APPLICATION NO.	FILING DATE	FIRST NAMED INVENTOR	ATTORNEY DOCKET NO.	CONFIRMATION NO.
10/785,241	02/24/2004	Brent J. Cornell	29718	1035
23482 7590 0225/2008 WILHELM LAW SERVICE, S.C. 100 W LAWRENCE ST			EXAMINER	
			KWIECINSKI, RYAN D	
THIRD FLOO APPLETON, V			ART UNIT	PAPER NUMBER
			3635	
			WAY DATE	DET HERDEL CODE
			MAIL DATE 02/25/2008	DELIVERY MODE PAPER

Application No. Applicant(s) 10/785,241 CORNELL, BRENT J. Office Action Summary Examiner Art Unit RYAN D. KWIECINSKI 3635 -- The MAILING DATE of this communication appears on the cover sheet with the correspondence address --Period for Reply A SHORTENED STATUTORY PERIOD FOR REPLY IS SET TO EXPIRE 3 MONTH(S) OR THIRTY (30) DAYS. WHICHEVER IS LONGER, FROM THE MAILING DATE OF THIS COMMUNICATION. Extensions of time may be available under the provisions of 37 CFR 1.136(a). In no event, however, may a reply be timely filed after SIX (6) MONTHS from the mailing date of this communication. If NO period for reply is specified above, the maximum statutory period will apply and will expire SIX (6) MONTHS from the mailing date of this communication - Failure to reply within the set or extended period for reply will, by statute, cause t

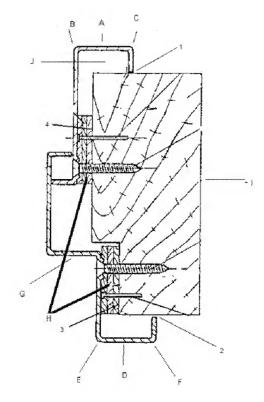
Claim 1:

Noach discloses a jamb assembly comprising:

(a) an elongate jamb having a length (Fig.1), and comprising an inner flange (A, below) having a first proximal edge (B, below) and a first distal edge (C, below), an outer flange (D, below) having a second proximal edge (E, below) and a second distal

edge (F, below), and a jamb face plate (G, below) extending between said inner flange at the first proximal edge and said outer flange at the second proximal edge, said elongate jamb defining an elongate cavity (hollow opening between the flanges, below) therein extending along the length of said elongate jamb, and extending a depth distance from at or adjacent an inner surface of said jamb face plate to an elongate opening of the cavity extending between said first and second distal edges of said inner and outer flanges;

- (b) a plurality of spaced apart spacing blocks (H, below), said spacing blocks extending from first proximal surfaces of said spacing blocks at the inner surface of said jamb face plate, to second outer surfaces of said spacing blocks displaced toward the elongate opening a distance less than the depth distance of the cavity, the second outer surfaces of said spacing of said spacing blocks thus being intermediate the inner surface of said jamb face plate and the elongate opening of the cavity (Fig.2; below);
- (c) as a separate and distinct element, at least one elongate reinforcing insert (I, below) received from the second outer surfaces of said spacing blocks, in the cavity, to the elongate cavity opening.
